Title: Advisory Committee on Reactor Safeguards
Combined Thermal-Hydraulic Phenomena/
Future Plant Design Subcommittee Meeting
OPEN SESSION

Date: Friday, February 15, 2002

CHAIRMAN KRESS: This is a continuation of our Joint Subcommittees on Thermal-Hydraulic Phenomena and Future Reactor Designs, dealing with the subject of Phase 2 review of the AP1000 certification.

Hot Leg Velocity vs. Time

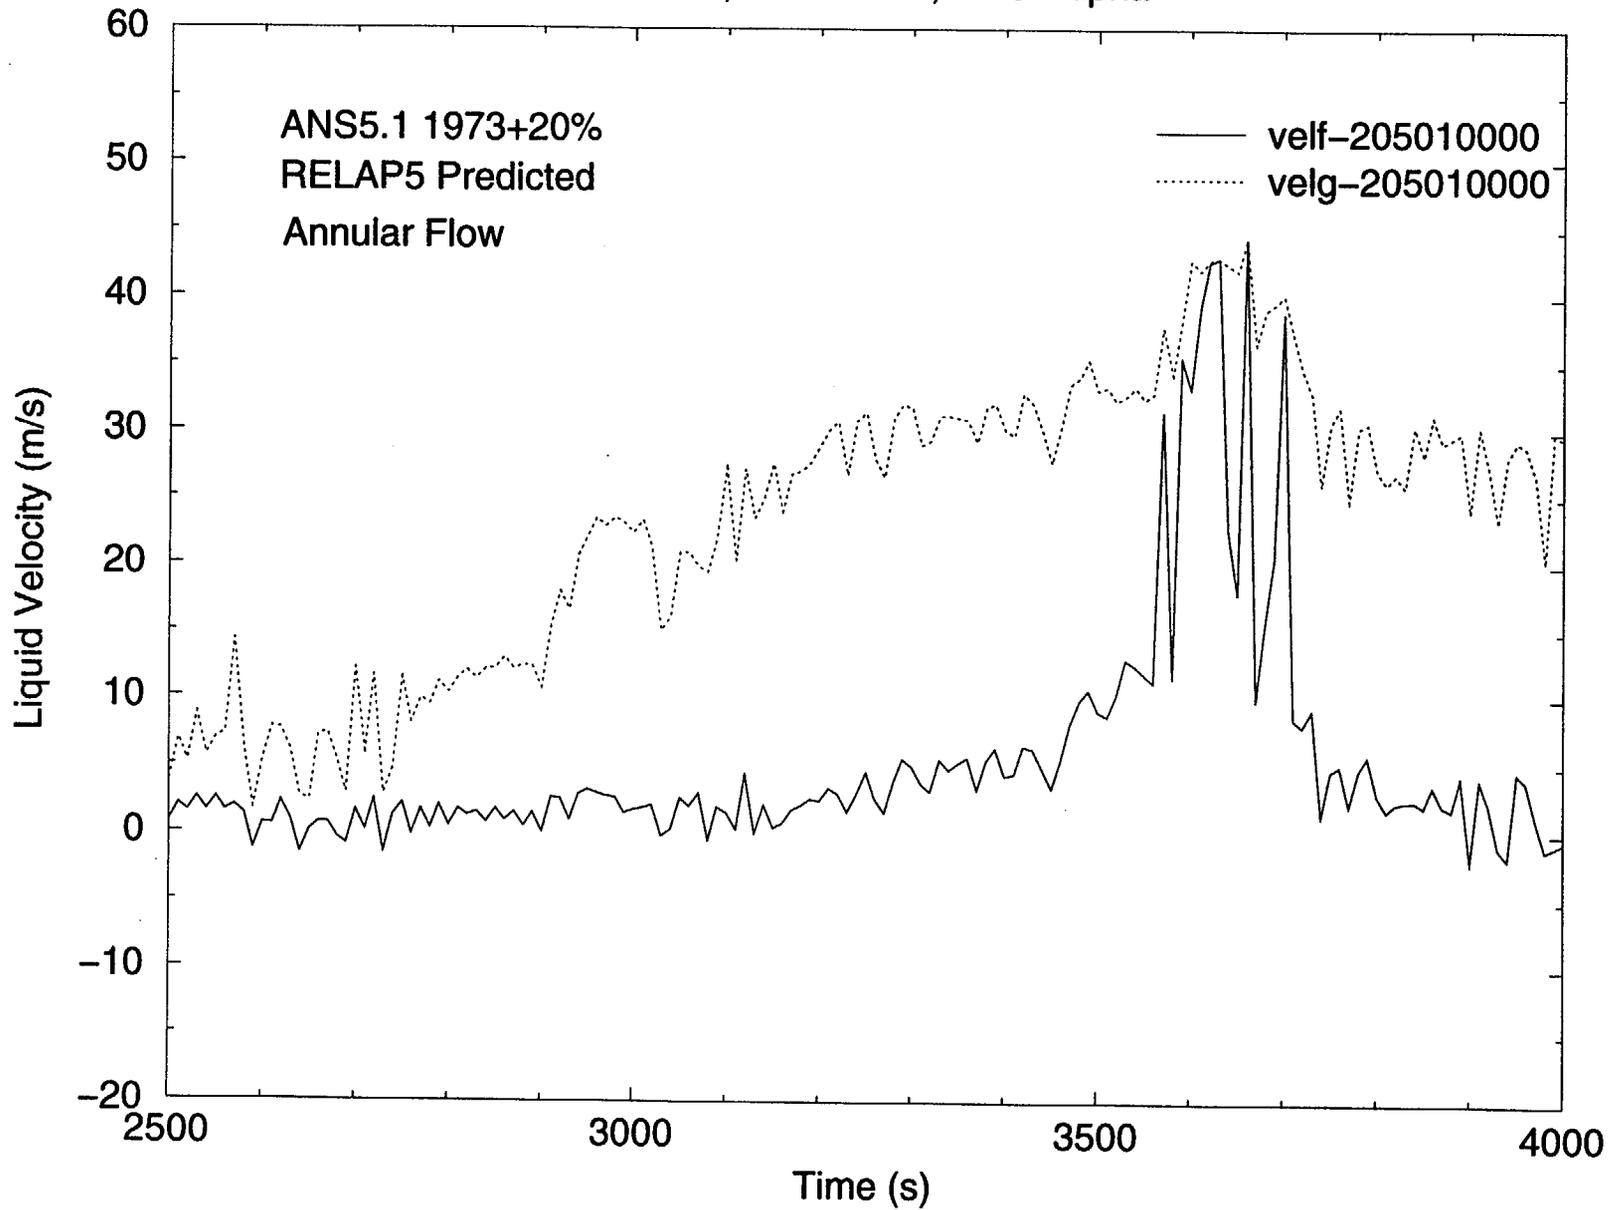
5 MR. JENSEN: The liquid is the bottom one,
6 and it's just kind of bouncing around zero. It's
7 fairly low. So ADS-4 opens at about 2900 seconds, and
8 then the IRWST comes on at around 3500 seconds, which
9 is this big water slug coming out. But I guess what
10 I'm trying to show here is the steam velocity. It's
11 pretty high in this hotleg.
